Introduction

Thank you for your interest in the Xilinx Spartan™-3AN family XC3S50AN FPGA device engineering samples. Although Xilinx has made every effort to ensure the highest possible quality, these devices are subject to the limitations described in this errata notification. These errata do not apply to the XC3S50AN production FPGAs.

Table 1: XC3S50AN Devices Affected by These Errata

Figure 2: XC3S50AN ES Package Dimensions with Exposed Pad

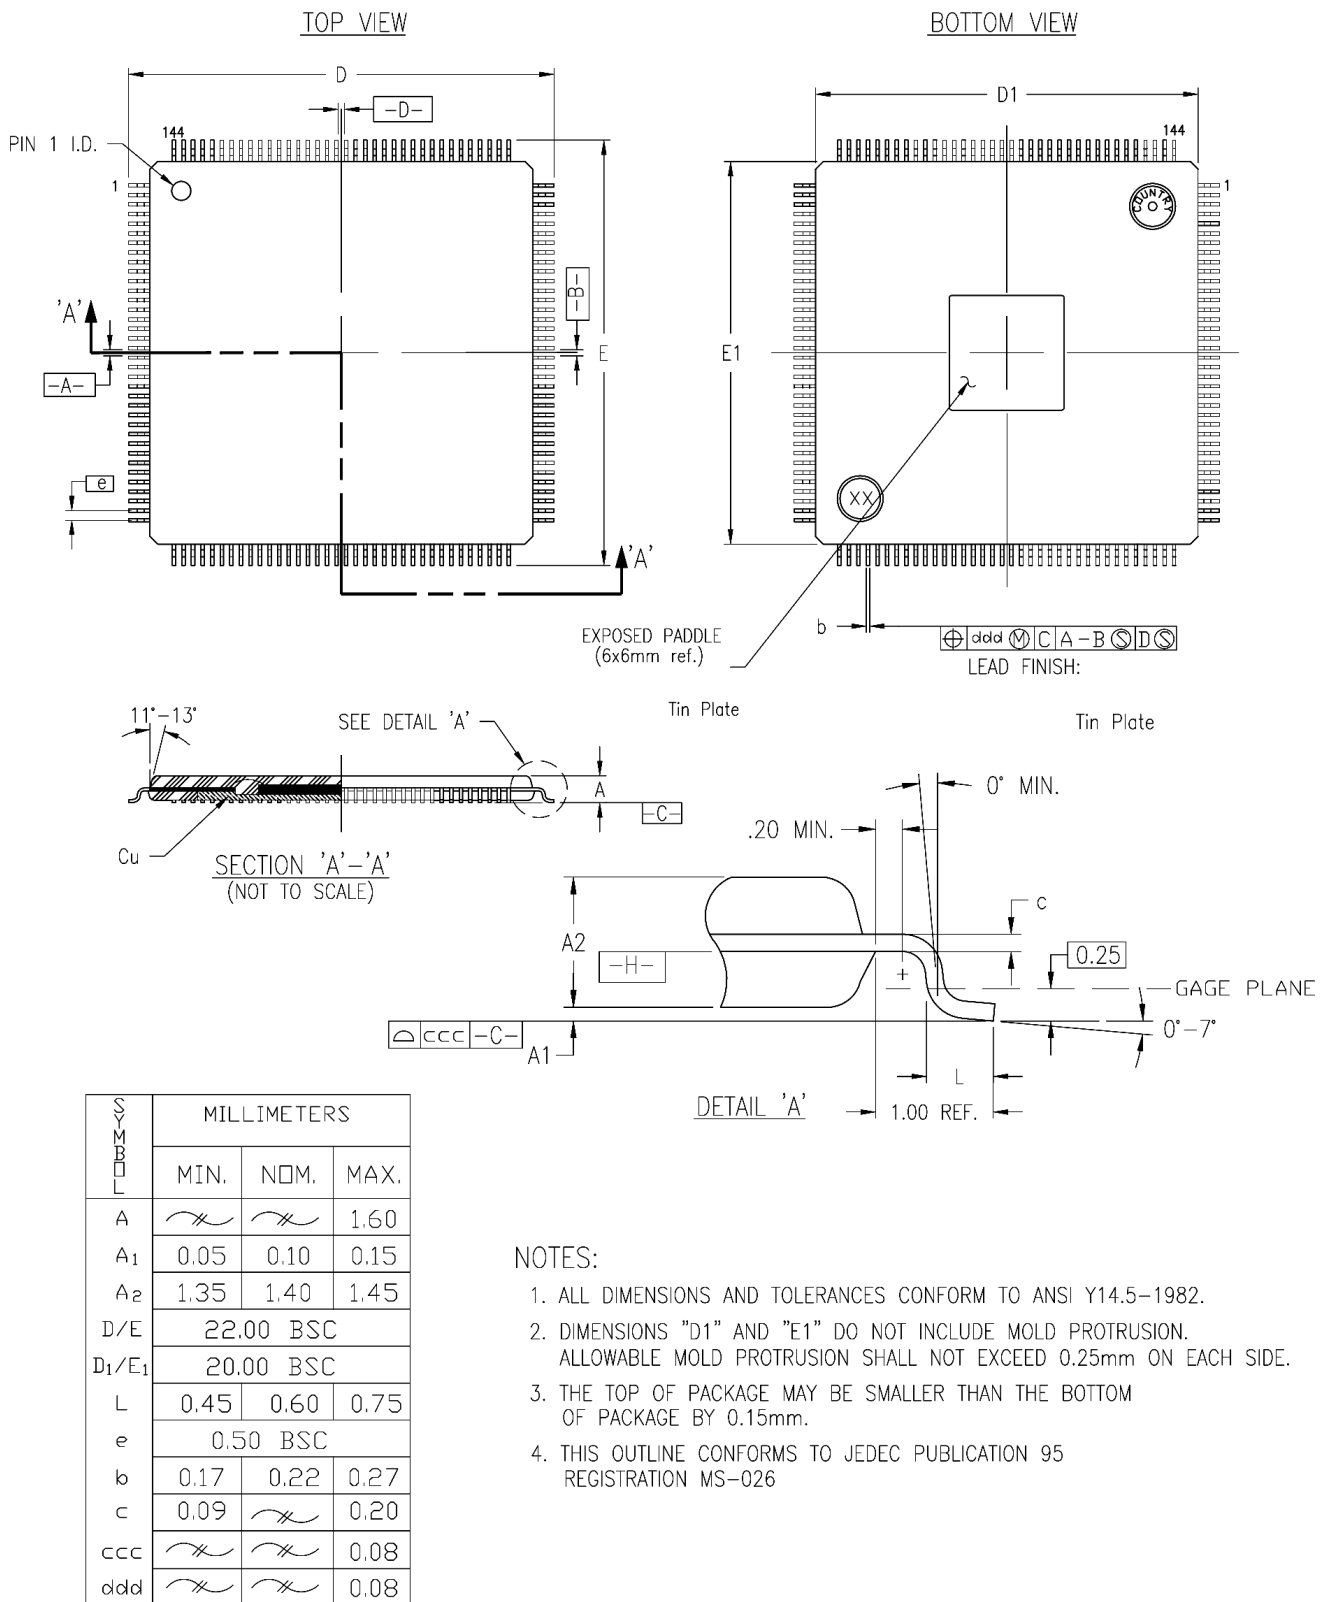
The XC3S50AN FPGA engineering samples are offered in only one package and therefore this issue could affect all applications. This issue specifically restricts applications that route signals under the package.

The XC3S50AN engineering samples are assembled in a non-standard package with an exposed metal pad on the bottom. The package dimensions shown in [Figure 2](#) match those of the standard TQG144 package which will be used for production. As shown in [Figure 2](#), the package used for the engineering samples has an exposed pad in the middle of the bottom side, with maximum dimensions of 6mm x 6mm. The exposed pad package is typically used to enhance thermal characteristics and signal integrity, but is not being used for those reasons. The package is only a temporary solution until the production package is available. All thermal, material, and reliability characteristics of this package are similar to those of the standard package.

Do not route signals in the area of the exposed pad. The exposed pad can be unconnected on the board, or it can be connected to GND. Do not use the engineering samples for qualification.

This issue has been corrected in production revisions of the XC3S50AN device. Production devices use the standard TQG144 package, with a different assembly process and without the exposed pad.
